December 20, 2006

Subject: **Response to Comments**
Former Sears Auto Center #1058B
2600 Telegraph Ave.
Oakland, California
Case I.D. # STID 1082
For Sears Holdings Management Corporation

Alameda County Environmental Health (ACEH) staff has reviewed "Addendum to Site Closure Assessment" dated June 24, 2005, prepared by URS Corporation (URS). URS recommended the excavation of soils from borings CB3, CB5, and CB8 containing residual hydrocarbon concentrations that exceed California Regional Water Quality Control Board (RWQCB) San Francisco Bay Region's Environmental Screening Levels (ESLs). Before your case can be closed, we request that you address the following technical comments and send us the technical reports requested below.

PLOT PLAN WITH PROPOSED SOIL BORING LOCATIONS	
Project: Sears Auto Center #1058, 2600 Telegraph Avenue, Oakland, CA	
Project No.: 29863494	Figure 1
Date.: AUGUST 2006

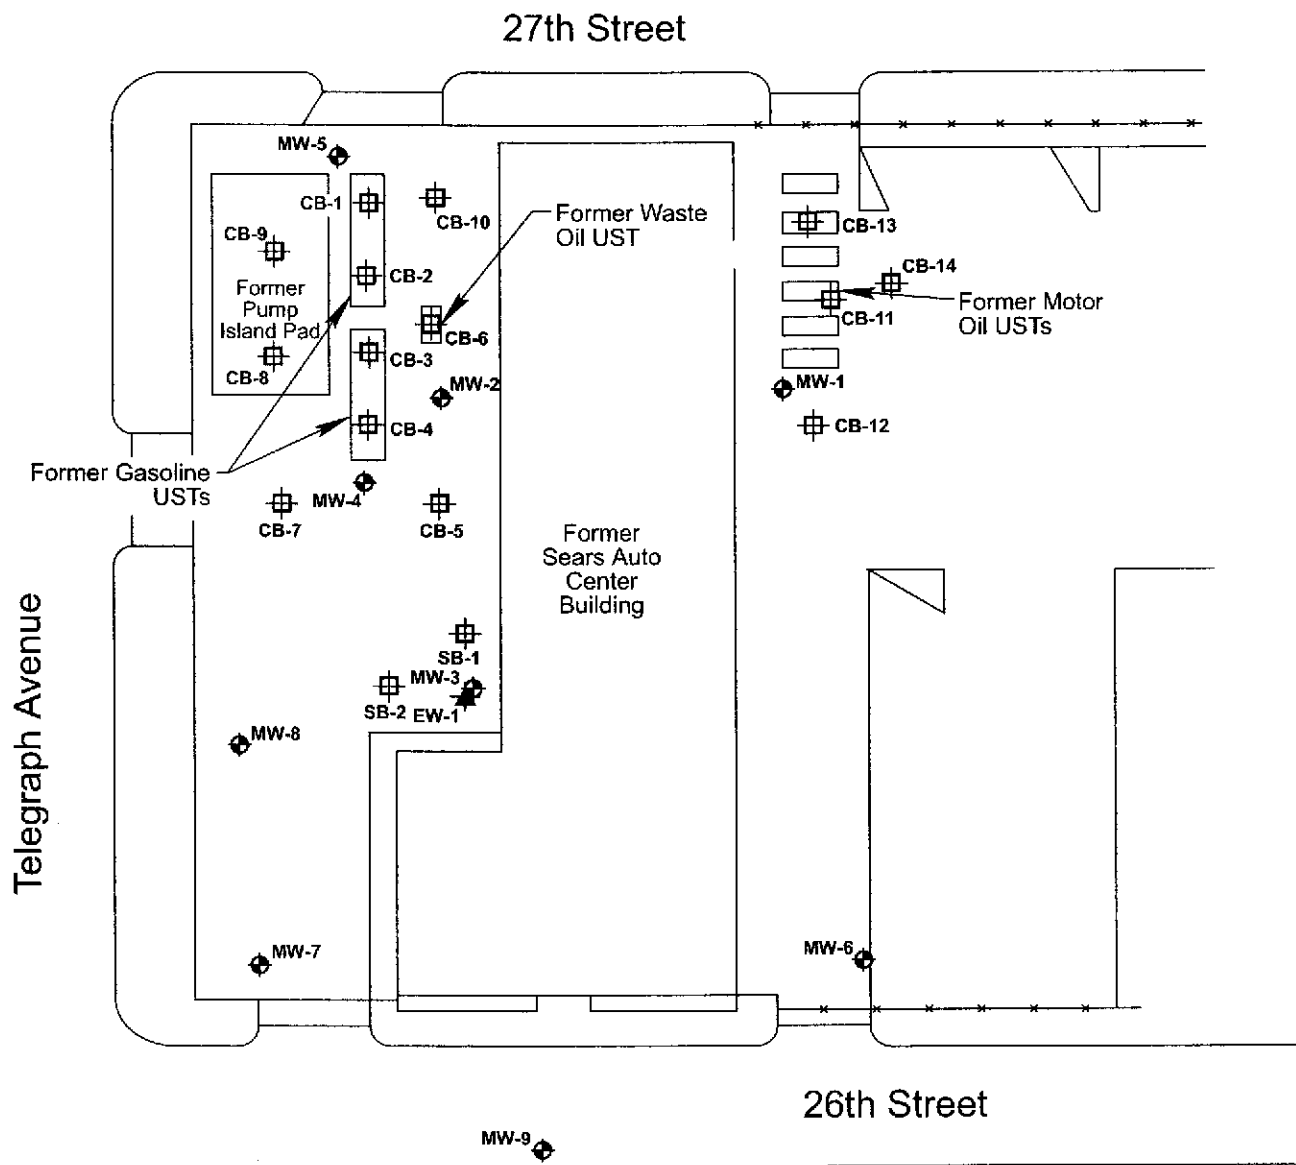
1) *Other soils exceeding ESLs – Soil samples collected during the installation of monitoring wells MW-2, MW-3, and MW-4, detected up to 3,400 micrograms/kilogram (mg/kg), 2,200 mg/kg, and 1,600 mg/kg, respectively. Please propose the excavation of these soils or indicate why these soils should not also be removed.*

On the basis of these results and due to the historical and outdated nature of the previous TPH detections, remedial action does not appear justified or warranted. However, there is no recent TPH data for the vicinity of well MW-3. Therefore, in order to further substantiate Site conditions, URS proposes collecting additional soil samples at two locations in the vicinity of well MW-3 as shown on Figure 1.

Attachment A: Figure Showing Revised Confirmation Soil Boring Locations

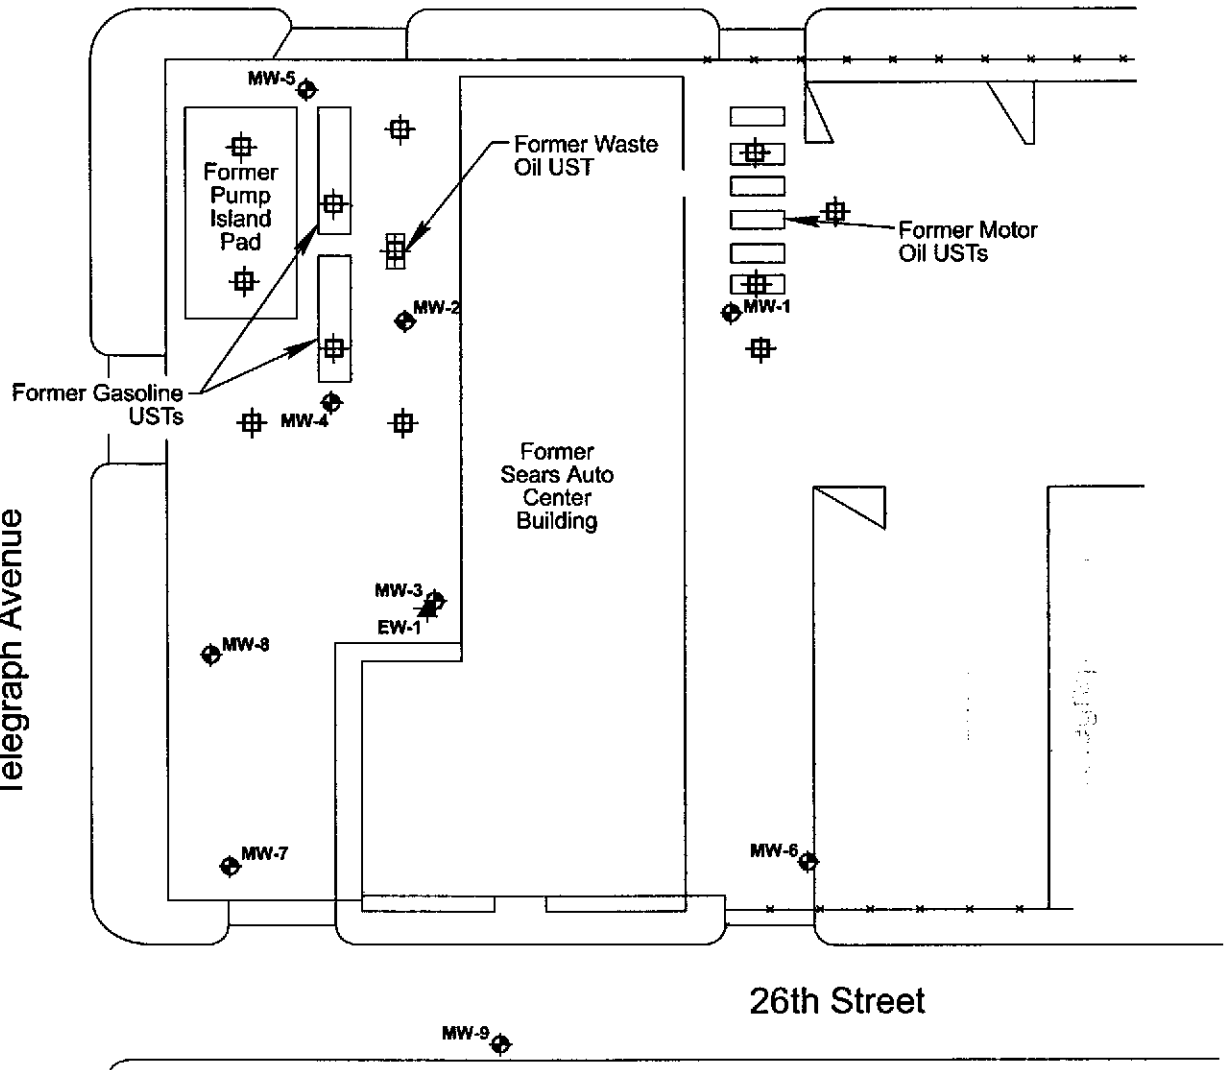
- a. *T5 – The report describing the removal of the tanks did not include T5 as one of those with poor integrity and holes. T6 was noted to have a cracked seam on its southwestern weld and the soil to the north and south of the tank was stained. It appears that sample locations ought to be by T6 instead of T5. If you agree, propose sample locations by T6.*
- b. *In the area of the gasoline tanks – We do not have a report describing the removal of these tanks, including sample locations and results. Without such information, sampling may be duplicated. Please provide so that we can determine the locations previously sampled.*

The proposed confirmation boring locations were placed in a grid pattern throughout the former tank locations to collect current data from the former underground storage tank (UST) areas regardless of the historical site data. The proposed boring location in the area of removed UST-T5 will be moved to UST-T6. A figure showing the revised proposed confirmation soil boring locations is provided in Attachment A.
